Super-PON Draft Updates

IEEE P802.3cs, April 02, 2020
Liang Du (Google)

Power levels - DS

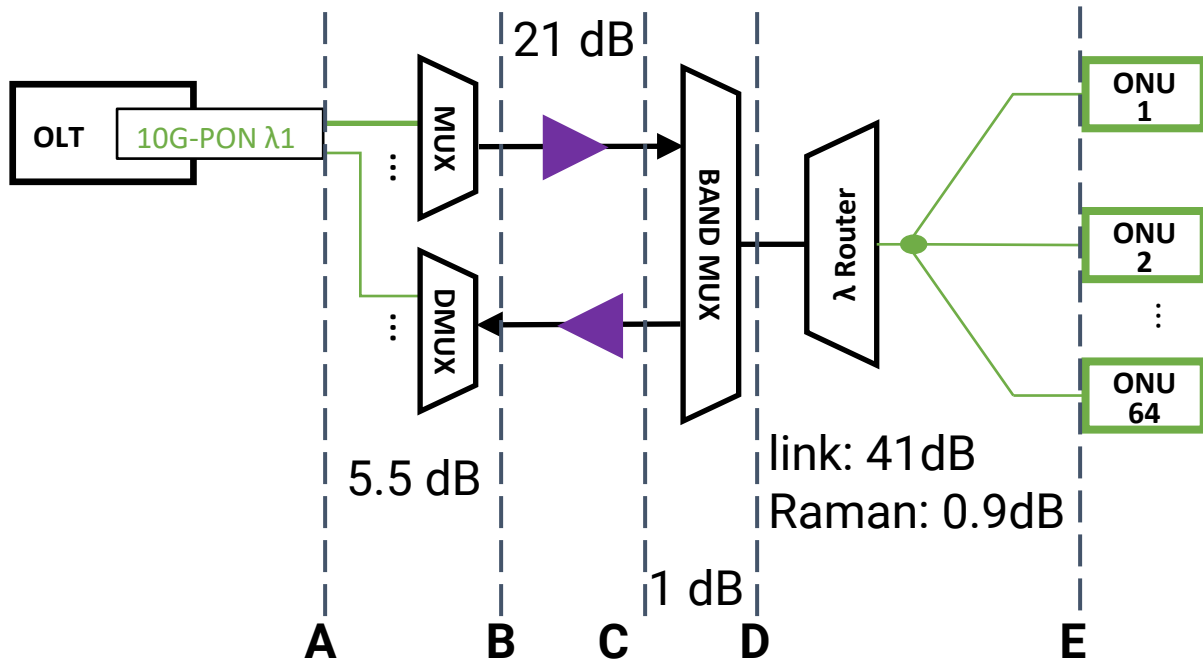
- OLT Tx power should be: -2.5 dBm to +1.5 dBm
- Allow for 4 dB spread between min and max
- Operator to balance the powers
- Sensitivity to be adjusted to -31 dBm to reflect the assumed gains from LDPC
- 1.1 dB for link penalty

Power levels - US

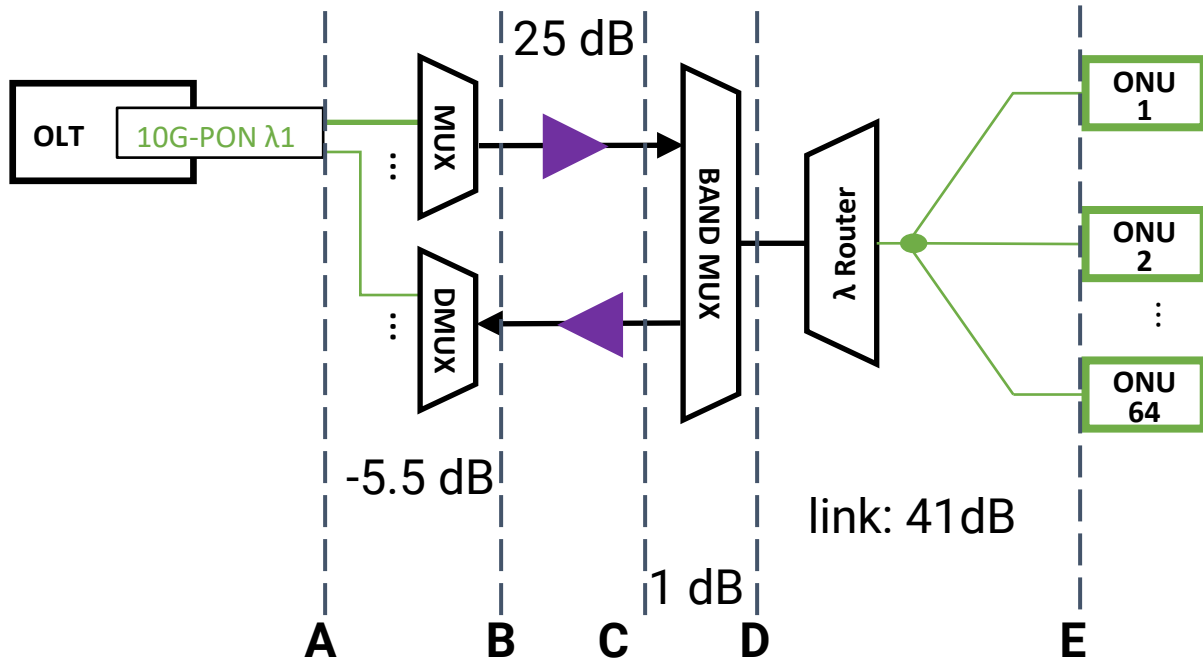
- 10G ONU Tx power: >4 dBm @ 6dB ER
- 2.5G ONU Tx power: -0.5 dBm to 4.5 dBm
- OLT sensitivity needs to be better than -20.6 dBm to account for 2.1 dB of TDP

Power vs ER curves

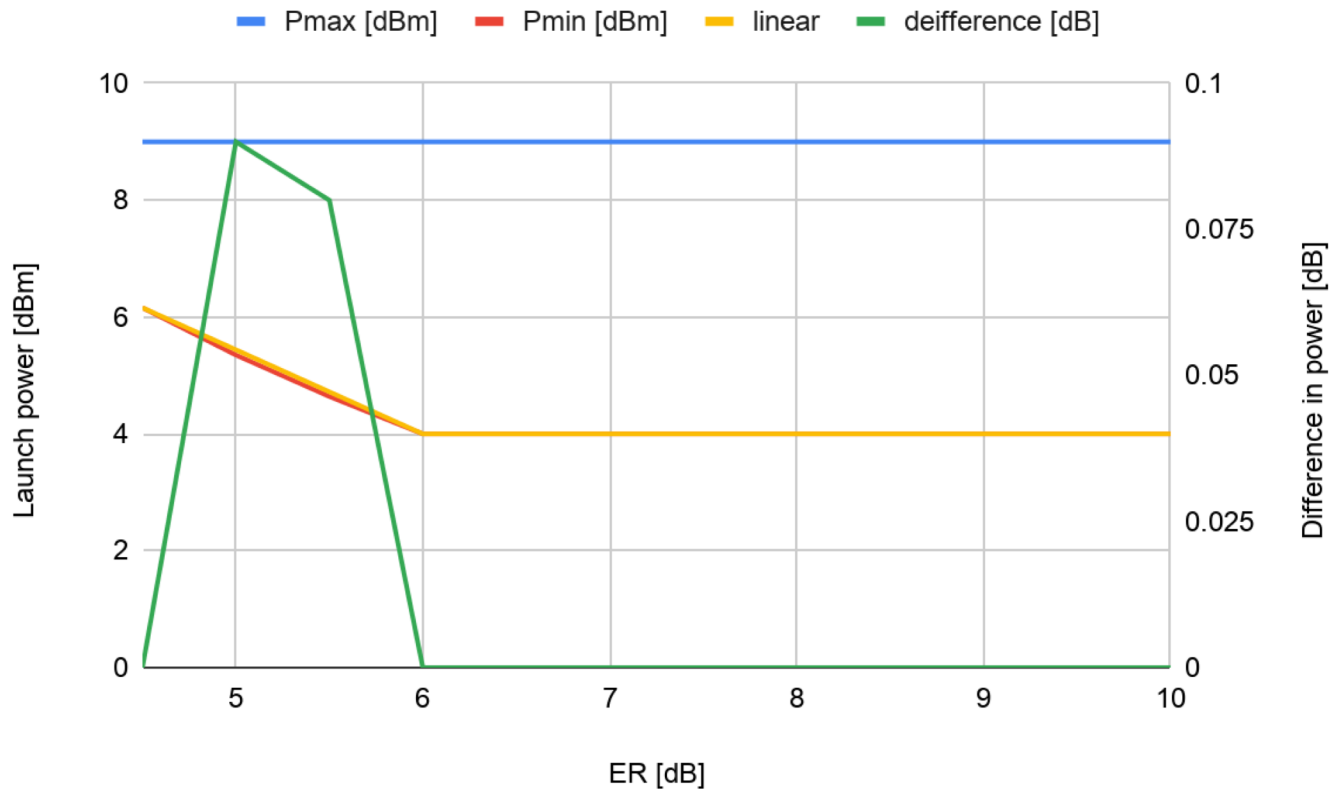
- Max power of 9 dBm
- Does not allow any power reduction for ER >6 dB

Power vs ER curves

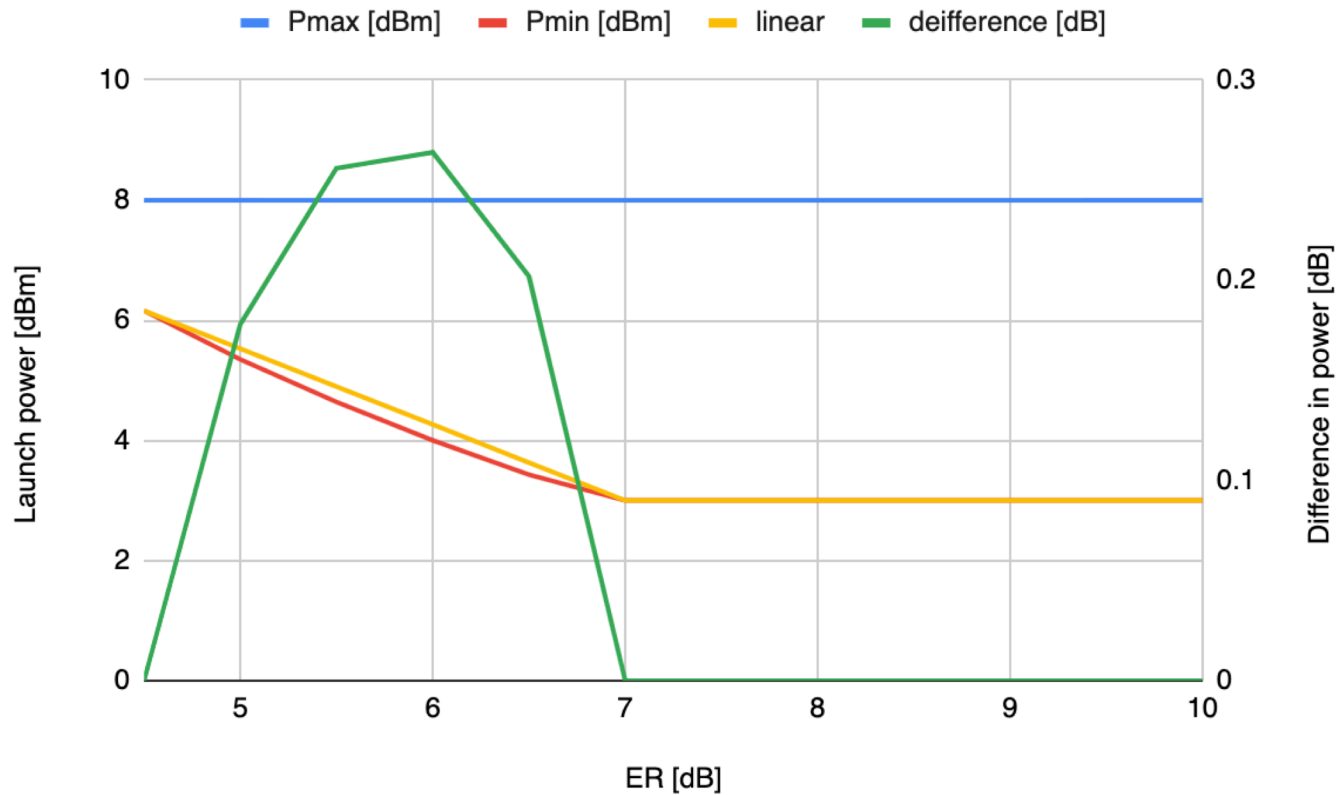
- Max power of 8 dBm
- Allows for 3 dBm at ER ≥ 7 dB ----> Better for EML ONUs
